# 3rd & Cherry

DESIGN REVIEW BOARD  
2<sup>nd</sup> RECOMMENDATION MEETING

Project Address: **601 4th Avenue**  
SDCI Project #: **3028747**

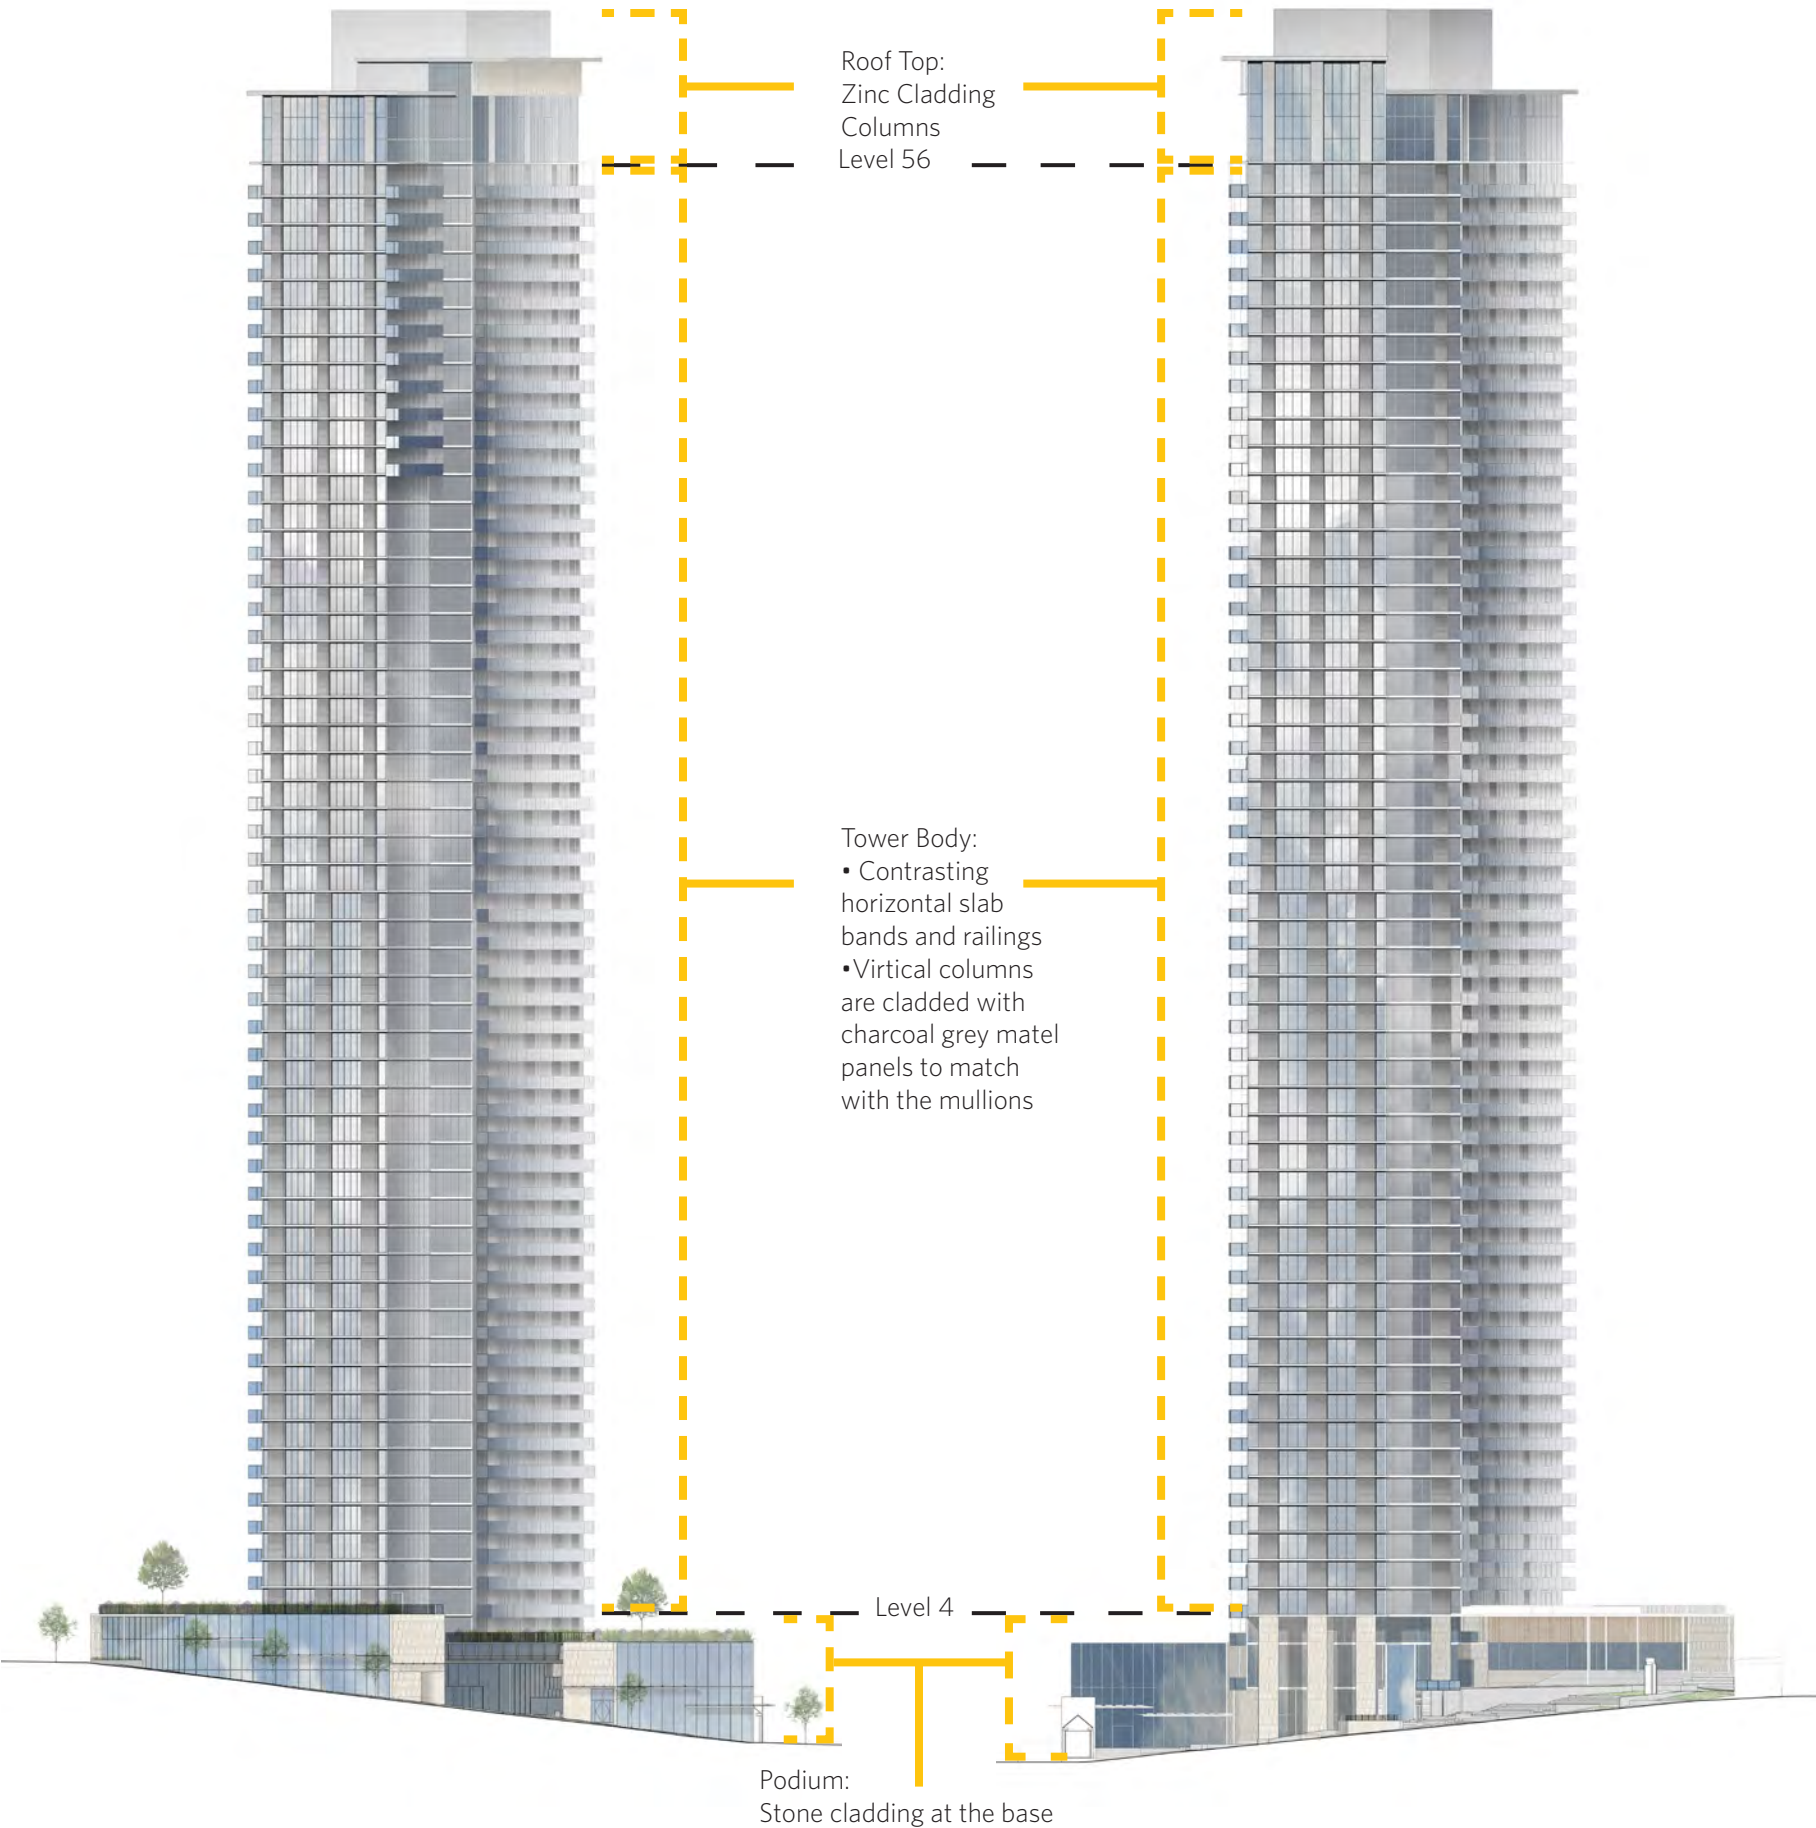
Provide a design at the north and south façades where the structure blends in with the curtain wall to provide a unified design. (B4.3)

The horizontal expression of the tower is emphasized by using charcoal grey panels to blend the vertical columns with glazing at either end of the tower.

The base of the tower is expressed with glass and stone, whereas the tower is expressed by the horizontal balcony slabs , glass and charcoal grey panels/ mullions for a cleaner, more modern look.

The tower top has been refined by stressing the verticality of the amenity columns by cladding them in Zinc panels that match the rest of the roof design.
